Comment on Eversource position statement, X-178 complete rebuild.

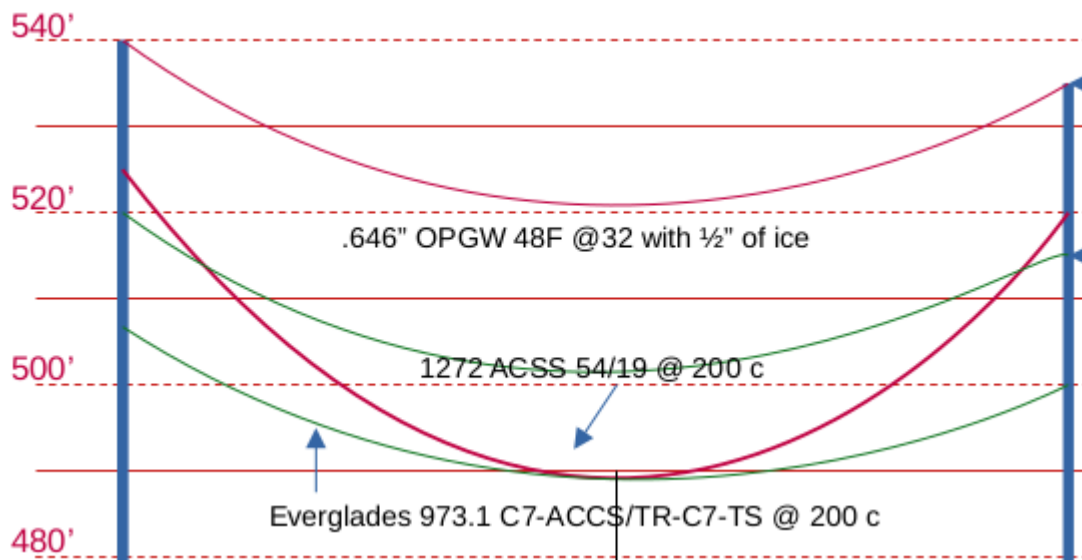
Height increases are driven by Eversource’s plan to install OPGW, larger high-sag conductor, and Eversource’s guaranteed rate of return of 11+% on its investment. The clearances are also greater than required by Code as is clear in the profile drawings. So the structures are taller than is required for Code compliance. Eversource has not shown that it cannot comply with Bethlehem’s height restrictions by using ACCC-type conductor, of a lower amperage than the 1272 if necessary and by not installing the easement-violating OPGW. (Below: 739’ span:)

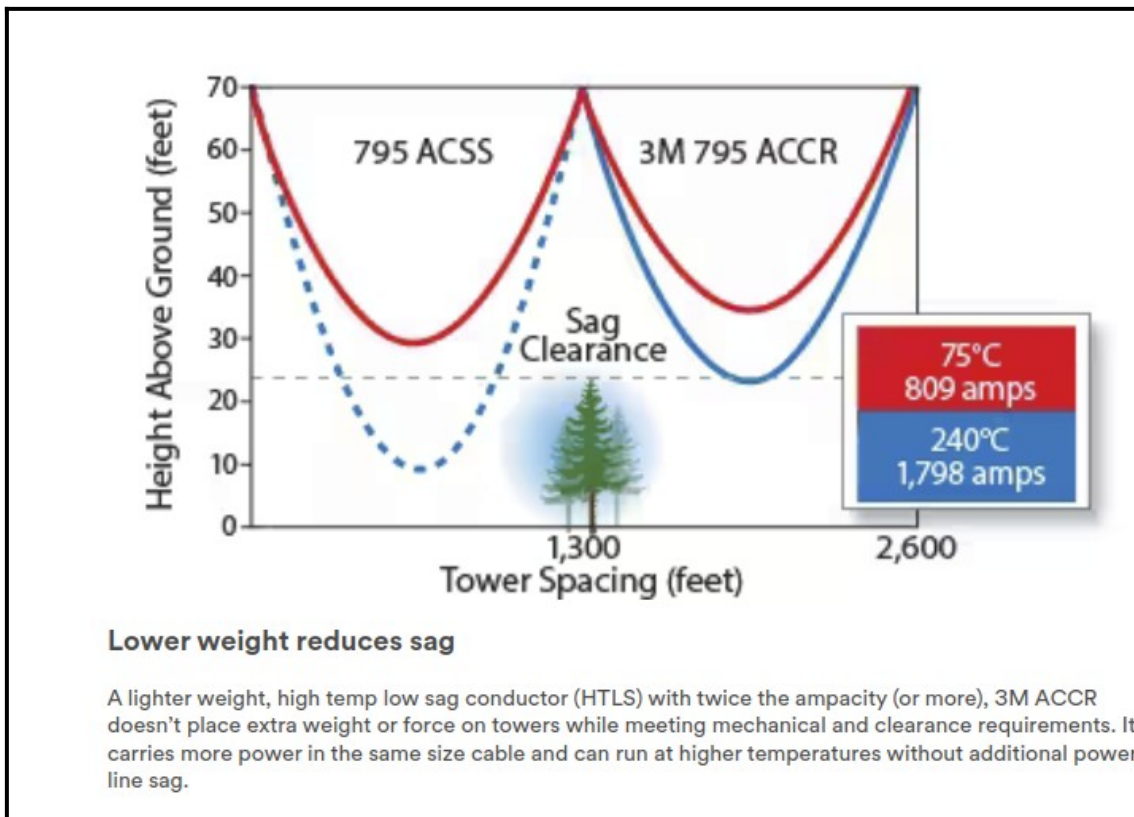
Where are the profiles showing that Eversource could not, using advanced ACCC type conductor, lower structure heights by 20' on average, which would allow Eversource to use the existing structures after cutting off the decaying pole tops inspection notes mention frequently?

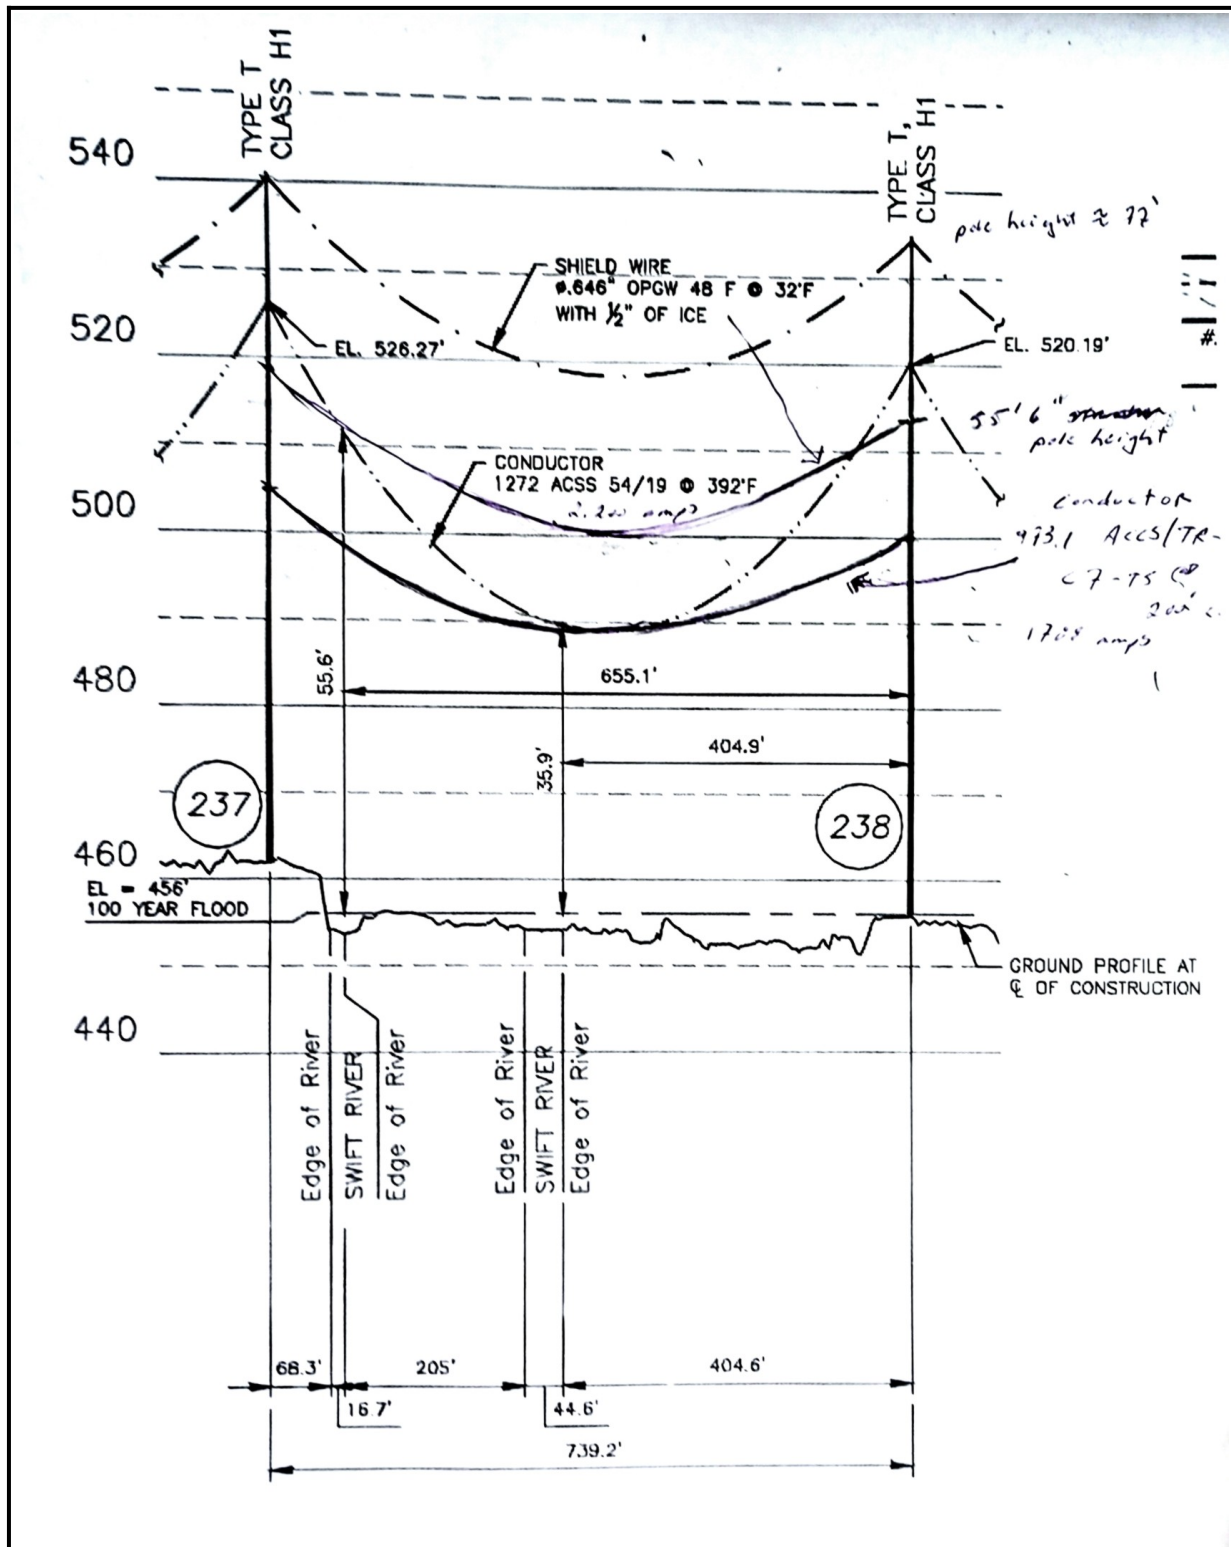
Lowering the 55' 6" structure with the ACCS/TR conductor 13' to reduce the clearance to 22.9' would allow a structure height of 42' 6". Using static wire or SkyWrap fiber on the conductors would lower the structure height by another 5', to 37' 6".
